FIELD OBSERVATION REPORT

REPORT NUMBER F-71

PROJECT: 660 5th Ave (660 Fifth Ave)

REF#: 172 **Curtain Wall WT-3: General Assembly of Steel Framing**

Photo 172.3 Overall view of the head condition.

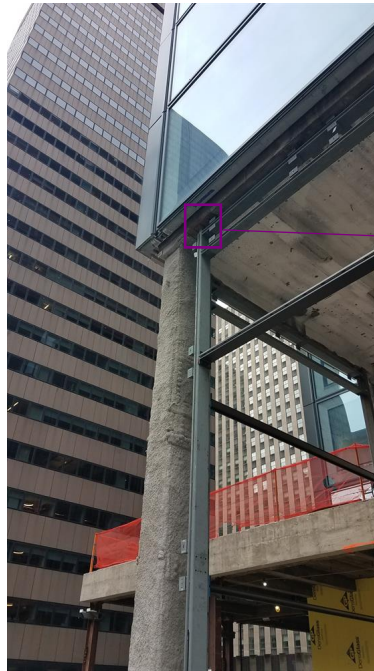
Socotec spot checked previously installed steel framing for WT-3 on the east elevation, 10th floor. Spot checks were performed from the ground level to confirm presence of slotted connection at the head, 5/8" thick sill plate (SS-02), Hilti bolt 5/8" diameter and 8-1/2" long (FS-94) installed at sill with welded flat washer, lock washer and nut, two bolts (FS-33) installed at horizontal structural steel to the vertical structural steel, and presence of vertical structural steel (ST-13). The work in progress was observed to be in general accordance with the approved as noted WT-3 shop drawings (submittal 084423-037-02), with the exception of the following:

Photo 172.4 View of Hilti bolt at sill - 5/8" diameter x 7" length

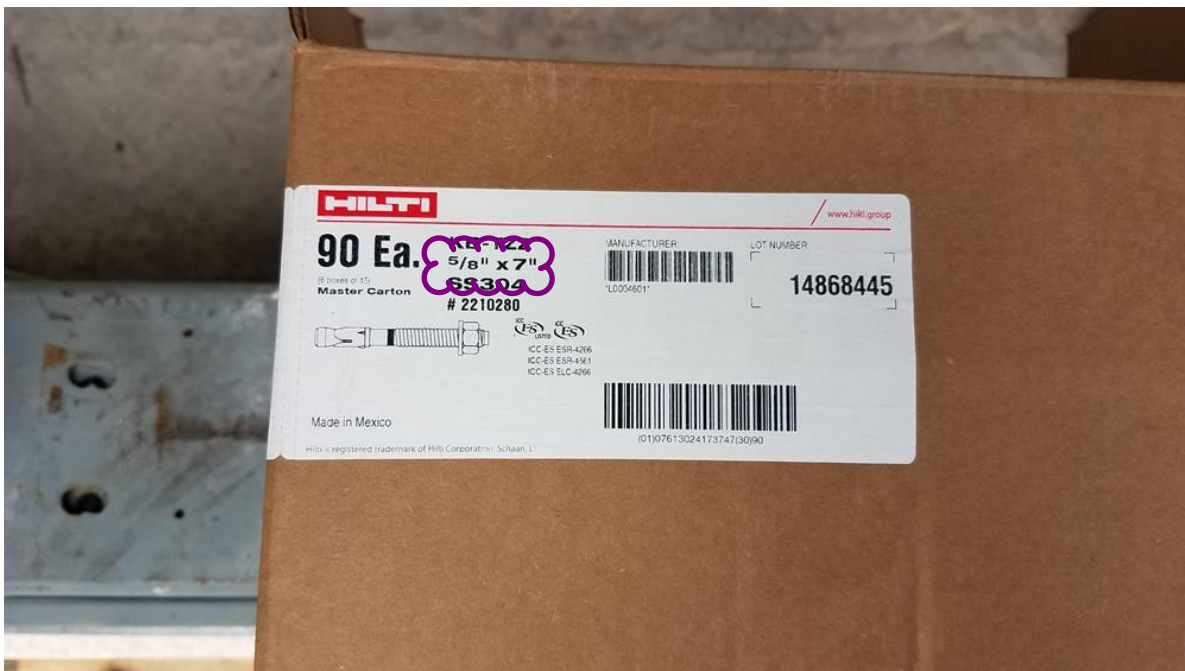
1. WT-3 shop drawings (084423-037-02) and calculations (084423-040-00) are not signed and sealed by NYS PE. Island advised that they will be submitting updated shop drawing and calculations, signed and sealed by NYS PE. - OPEN
2. The shop drawing sheet EWS-552rev1, calls for fastener FS-94 at the sill. The fastener schedule calls for FS-94 to be 5/8" diameter and 8-1/2" long. However, in the field the bolt box noted the length of the bolt as 7" and when installed the embedment measured approximately 4". The calculations and shop drawings do not call out the required embedment. This was discussed with Island who advised that they will be submitted updated calculations that calls for 3-1/4" embedment. – OPEN
3. Two bolts on the south elevation were observed to be tilted. Island advised that this will be corrected in the field– OPEN

1. Island for formally submit WT-3 shop drawings and calculations, signed and sealed by NYS PE.
2. Island to formally submit the updated calculations, showing embedment, signed and sealed by NYS PE .
3. Island to remediate the observed screwed bolts per the approved shop drawings. Turner to advise when the work is complete for Socotec's reinspection.
